DOCUMENT 00202 - ADDENDUM NUMBER 2

Subject: ADDENDUM NO. 2 TO THE BIDDING DOCUMENTS FOR:

Lakeview Gymnasium Renovation
Lakeview Recreational Center
Peoria Park District
2218 N. Prospect Road
Peoria, IL 61603

EXISTING/DEMOLITION SITE PLAN

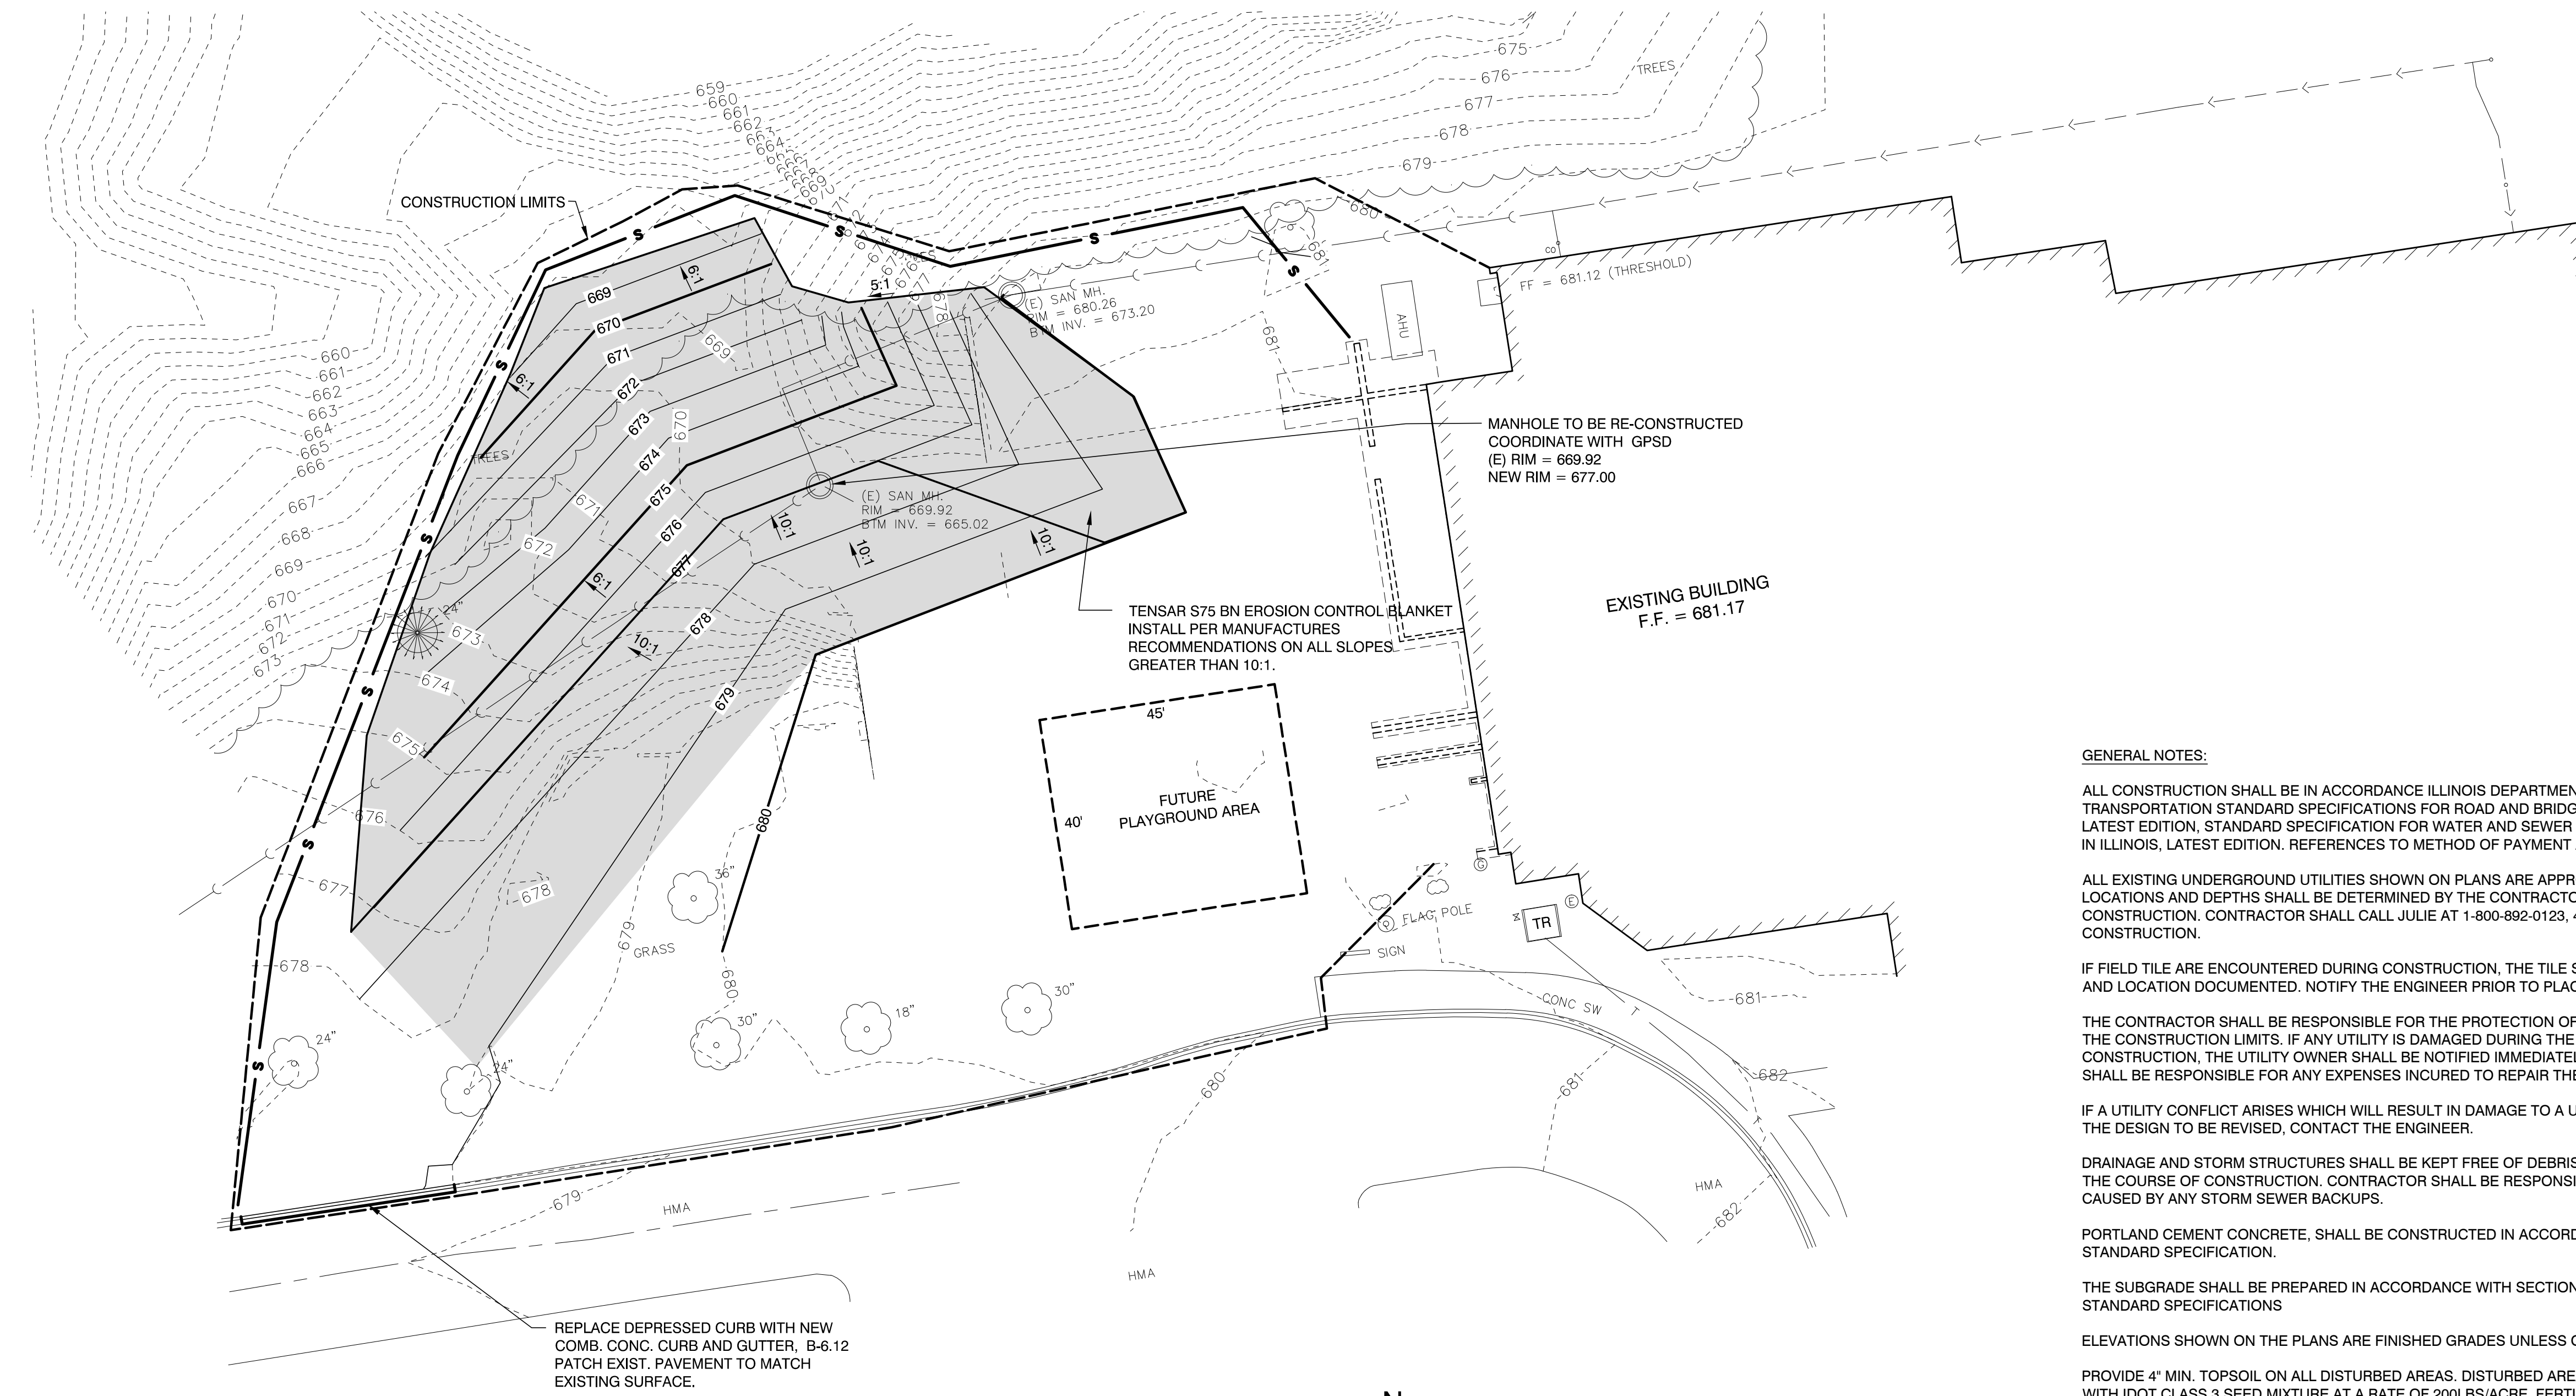
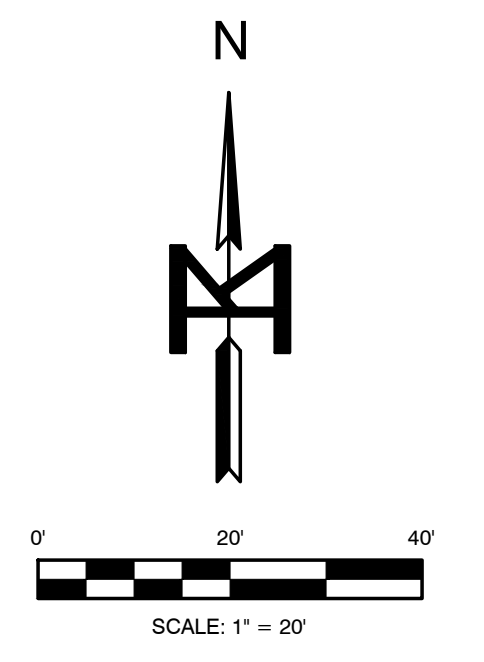
ADDENDUM #2

- SANITARY MANHOLE RECONSTRUCTION SHALL BE COMPLETED TO GPSD STANDARDS BY THE CONTRACTOR AND INCLUDED IN THIS CONTRACT. CONTRACTOR IS RESPONSIBLE FOR CONTACTING GPSD FOR A NO-CHARGE MAINTENANCE PERMIT AND COORDINATE INSPECTIONS. RECONSTRUCTION WILL REQUIRE FULL BARREL SECTIONS, FLAT SLAB TOP AND ADJUSTING RINGS LIMITED TO A MAX 8" FOR FINAL ELEVATION.
- ALL BASEMENT BACKFILL SHALL BE 'ENGINEERED FILL' AND COMPACTED TO 97% ALL IN ACCORDANCE TO SPEC. SECTION 312010- EARTH MOVING STRUCTURES.

SITE GRADING AND STORM WATER POLLUTION PREVENTION PLAN

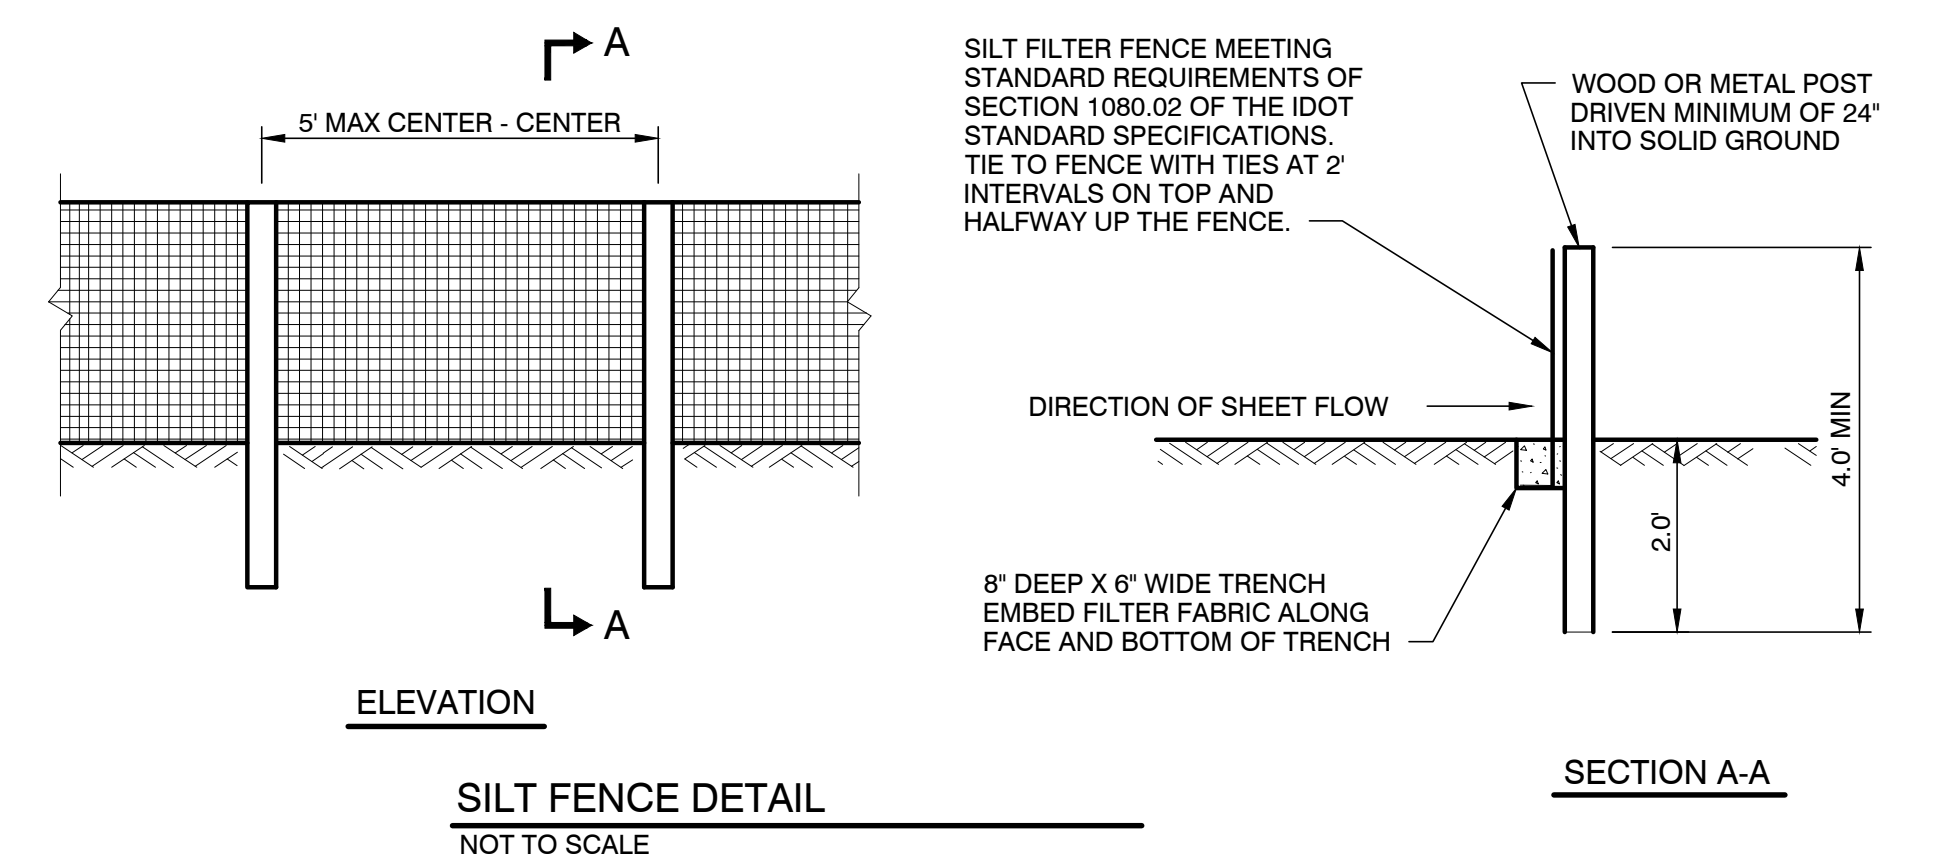
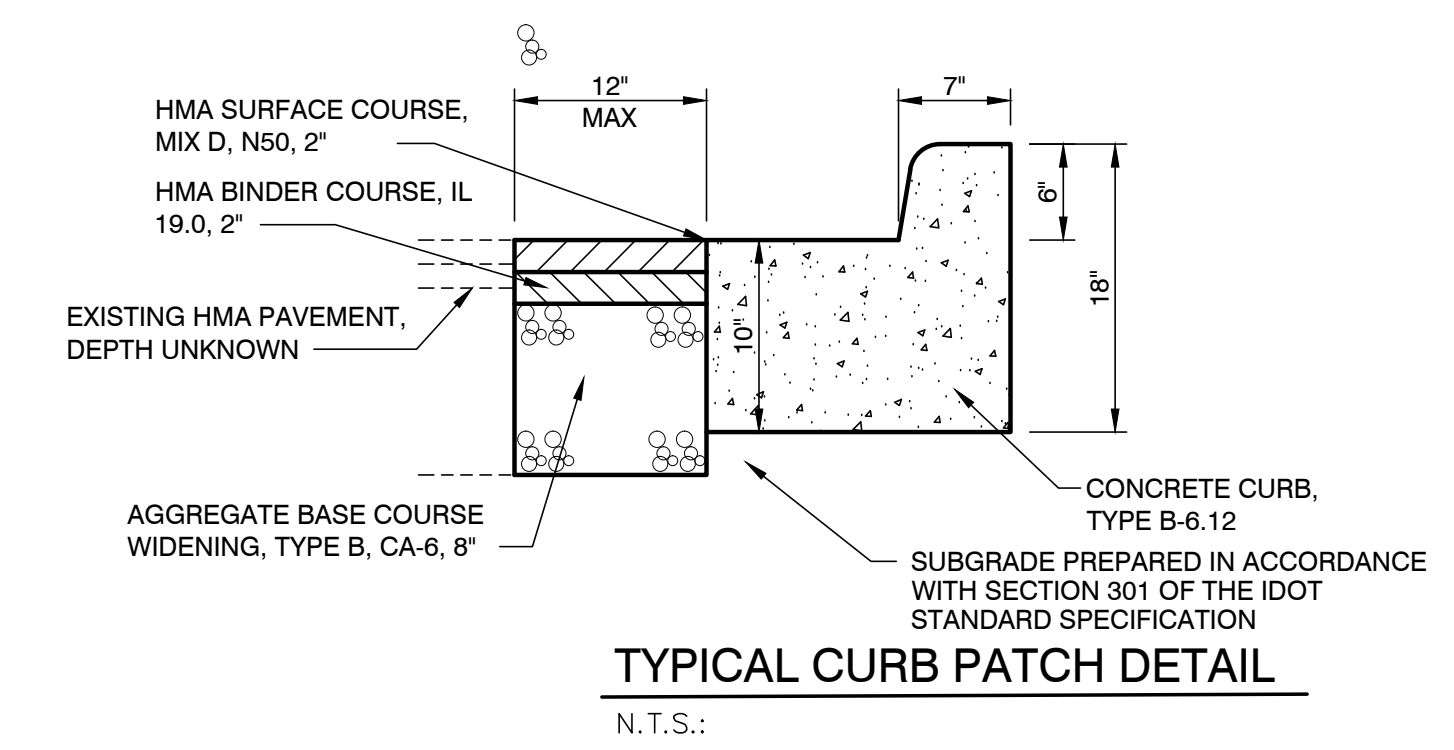
ADDENDUM #2

1. SANITARY MANHOLE RECONSTRUCTION SHALL BE COMPLETED TO GPSD STANDARDS BY THE CONTRACTOR AND INCLUDED IN THIS CONTRACT. CONTRACTOR IS RESPONSIBLE FOR CONTACTING GPSD FOR A NO-CHARGE MAINTENANCE PERMIT AND COORDINATE INSPECTIONS. RECONSTRUCTION WILL REQUIRE FULL BARREL SECTIONS, FLAT SLAB TOP AND ADJUSTING RINGS LIMITED TO A MAX 8" FOR FINAL ELEVATION.
2. ALL BASEMENT BACKFILL SHALL BE "ENGINEERED FILL" AND COMPACTED TO 97% ALL IN ACCORDANCE TO SPEC. "SECTION 312010- EARTH MOVING STRUCTURES".
